Proposal for Supplement 1 to the 05 series of amendments to UN Regulation No. 46 (Devices for indirect vision)

The text was produced by the Taskforce on UN R46 and contains only the clarifications of the existing text and solely the amendments not modifying existing technical requirements and not making transitional provisions necessary, presented in the informal document with the proposal for the 06 series of amendments to UN Regulation No. 46, also presented for the 126th session of GRSG.

- (i) Edge of the reflecting surface enclosed in a protective housing
- (ii) Reflecting surface projects beyond the protective housing in a specific adjustment position
- (iii) Edge of the reflecting surface not enclosed by the protective

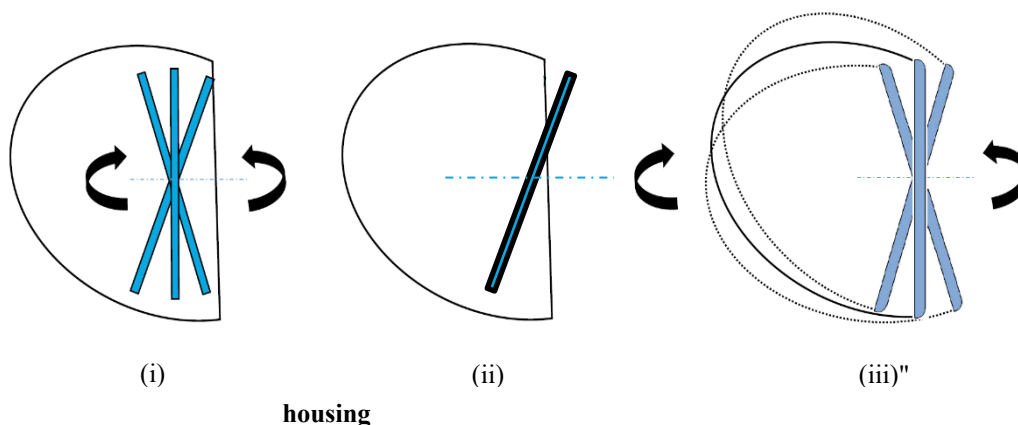
When the edge of the reflecting surface is enclosed in a protective housing, the radius of curvature "c" on the housing's perimeter shall be not less than 2.5 mm at all points and in all directions, figure below (i).

When If the reflecting surface projects beyond the protective housing in any adjustment position (figure below (ii)), the radius of curvature "c" on the edge of the projecting part shall be not less than 2.5 mm and the reflecting surface shall return into the protective housing under a force of 50 N applied to the point of greatest projection, relative to the

protective housing, in a horizontal direction, approximately parallel to the longitudinal median plane of the vehicle.

When the edge of the reflecting surface is not enclosed by the protective housing independent from any adjustment position, the radius of curvature "c" on its perimeter shall be not less than 2.5 mm at all points and in all directions and shall apply to the edge of the projecting part, figure below (iii).

"Figure 9
Figure 9.1
 Class VI field of vision for side-steered vehicle"

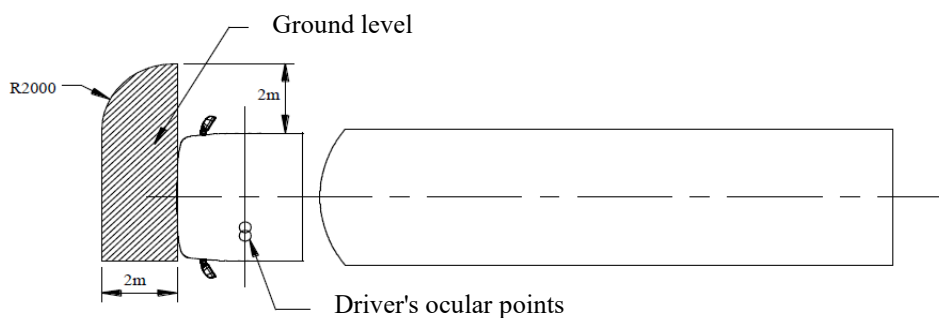
"15.2.4.6.1. The field of vision shall be such that the driver can see at least a flat horizontal portion of the road, which is **for side-steered vehicles** bounded by:

- (a) A transverse vertical plane through the outermost point of the front of the vehicle;
- (b) a transverse vertical plane 2,000 mm in front of the plane defined in (a);
- (c) a longitudinal vertical plane parallel to the longitudinal vertical median plane going through the outermost side of the vehicle at the driver's side; ~~and~~

- (d) a longitudinal vertical plane parallel to the longitudinal vertical median plane 2,000 mm outside the outermost side of the vehicle opposite to the driver's side; **and**
- (e) ~~The~~ **the** front of this field of vision opposite to the driver's side may be rounded off with a radius of 2,000 mm (see Figure 9.1).

Figure 9, renumber as Figure 9.1. and amend to read:

**"Figure 9.2
Class VI field of vision for centre-steered vehicle"**

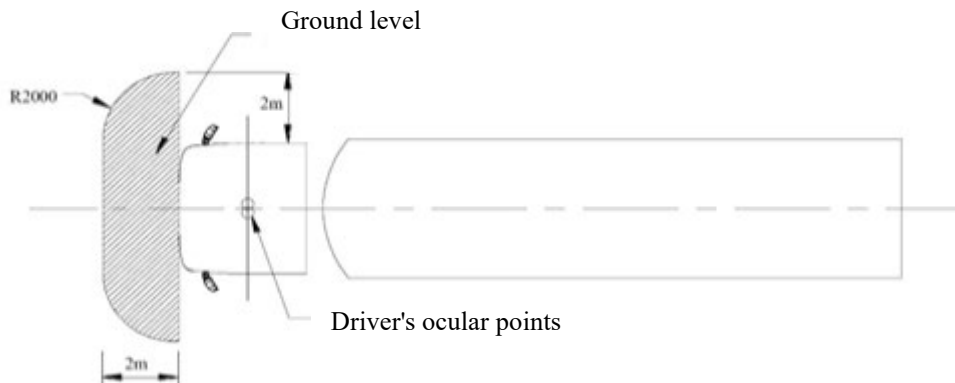
The field of vision shall be such that the driver can see at least a flat horizontal portion of the road, which is for centre-steered vehicles bounded by:

- (f) **A transverse vertical plane through the outermost point of the front of the vehicle;**
- (g) **a transverse vertical plane 2,000 mm in front of the plane defined in (a);**
- (h) **a longitudinal vertical plane parallel to the longitudinal vertical median plane 2,000 mm outside the outermost side of both sides of the vehicle; and**
- (i) **the front of this field of vision on both sides may be rounded off with a radius of 2,000 mm (see Figure 9.2).**

Insert a new figure 9.2., to read:

Figure 1

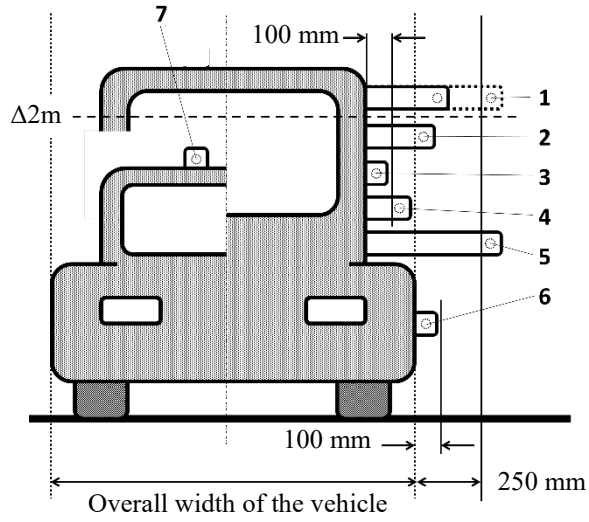
- 1 NO TEST (15.2.2.6.)
- 2 COMPULSORY
- 3 NO TEST (6.3.2.b))
- 4 NO TEST (6.3.2.a))
- 5 not permitted (15.2.2.6.)
- 6 NO TEST (6.3.2.b))

4. There could be different interpretations for the term "bodywork" in paragraph 6.3.2. as it is not defined. This could lead to different designs, for which it is unclear, if the pendulum test is needed. For clarification the text was amended and a new annex with a figure for further explanation was added. This also includes Class I Camera Monitoring system (CMS) on the vehicle's roof. The test is seen as unnecessary because a contact is seen as very unlikely.

Camera of CLASS I (CMS)

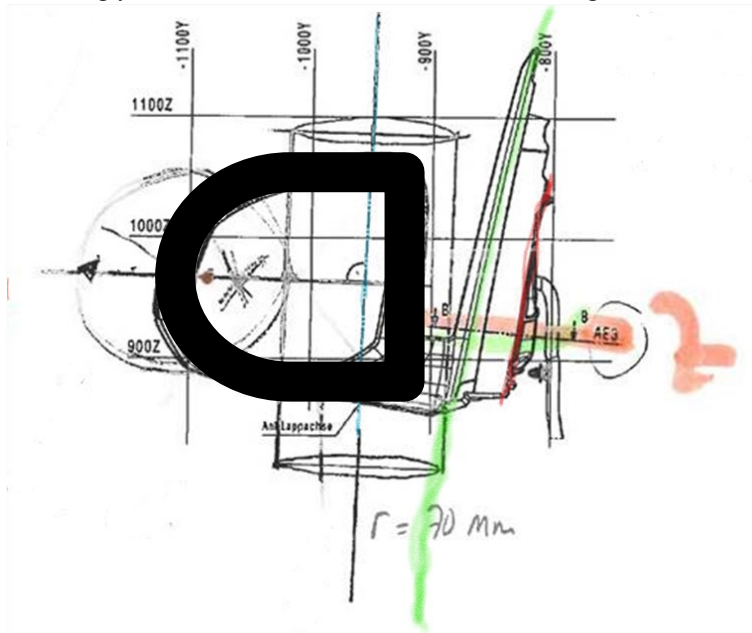
- 7 NO TEST (6.3.2.b))
